Re: Request for extension of Final Delivery Date
Lucero Apartments (f/k/a Oak Creek Village) Austin, Texas
Fannie Mae Forward Commitment No.: 874426
PNC Loan No: 310401235

Re: Revised Report for Enclosure Assessment of the Oak Creek Village Apartments
WJE No. 2016.3106.1

Figure 51. Roof access door threshold lower than industry standard 8-inch minimum.

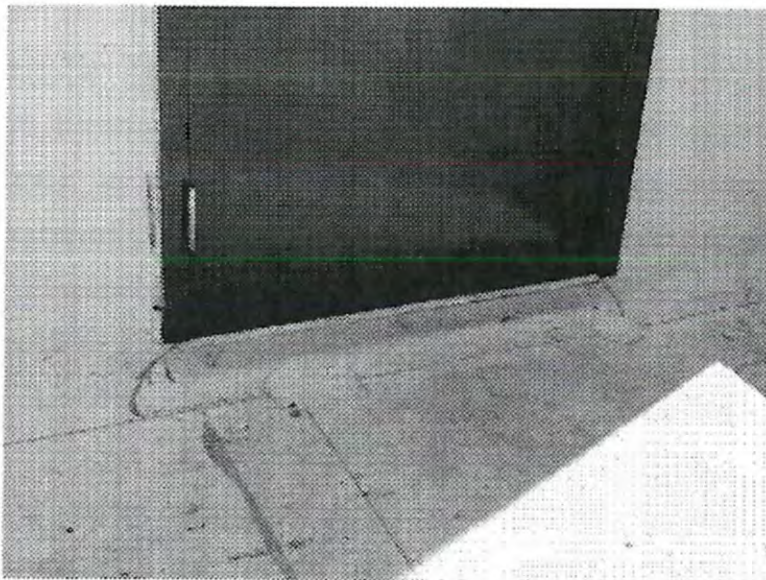
One roof door threshold was observed to be less than the standard 8-inch minimum height above the finished roof surface. The 8-inch minimum height is intended to protect against water buildup during heavy rains. At the low threshold, WJE recommends monitoring for water infiltration during heavy rain events and evaluation by the roof manufacturer for potential repair strategies to divert water away from the door.
